Cardinia Part 2 - Public Consultation Comment Table

Date: 10-Apr-26
 Agency: Melbourne Water
 Contact: [REDACTED]@melbournewater.com.au

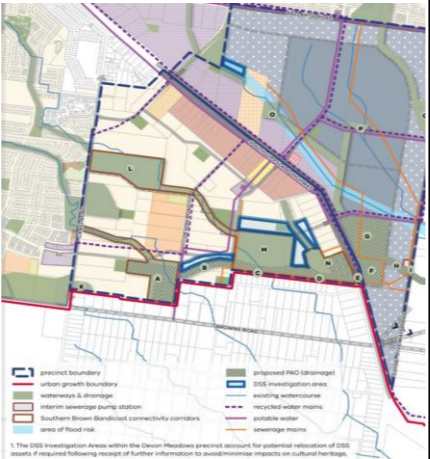
16	39	Figure 7 - Concept Plan	The functional design of Growing Grass Frog wetlands has been completed resulting in consolidation of two wetlands and repositioning to the western edge of the corridor. Given the environmental risk of a proposed equestrian trail, adjacent GGF wetlands, it is critical to ensure accurate information is provided for decision making.			
17	20	Figure 1 - Transitional Housing	General comment: The figure is unclear, are the shared path/nature strip and equestrian trail included in the 19m to be managed as grassland, as suggested in the figure? Melbourne Water does not support or facilitate the establishment of bushfire buffers on land under its management/ownership. Any fuel reduction zone or bushfire buffer must therefore be located outside the Cardinia Creek Conservation Area and outside any area intended to be managed by Melbourne Water.	Yes	Update Figure 1 to reflect this relates only to Part 1, through reference to Plan 4. Clarify how this relates to Plan 7 and Section 12 (Appendix C) Conservation Area interface.

18	39	Figure 7 - Concept Plan - Cardinia Part 2 Conservation Area 36	The equestrian trail is not appropriately placed. Figure 7 depicts the equestrian trail and shared user path located between the drainage reserve and conservation area. The MW GGF Masterplan Program has developed Functional Designs for GGF habitat wetlands in collaboration with the design of drainage assets. The GGF wetlands are located on the Conservation Area boundary and the drainage assets are in very close proximity, to minimise the land area required for stormwater treatment assets. Infrastructure permitted in this narrow space is the maintenance access track required for drainage asset and GGF wetland management. DEECA standard is for recreational trails to be a minimum 30 metres from a GGF wetland - importantly to limit disturbance to GGF wetlands. There is insufficient space at this location to accommodate the SUP and equestrian trail. During AV MW stated that "any proposed equestrian trails should be located outside of Melbourne Waters Drainage Reserve". MW equestrian trail requirements: - A minimum 30 metre setback required between GGF wetlands and the equestrian trail to minimise disturbance to and protect the GGF wetlands. - A minimum 20 metre setback required between MW WQT assets and the equestrian trail to ensure the effective functioning of the assets and to allow for ongoing access and maintenance. - MW will not maintain the equestrian trail, nor have any responsibility or liability in regards to it - The equestrian trail must not impede access to any MW assets	Yes	Relocate equestrian trail to the western side of the drainage reserve.
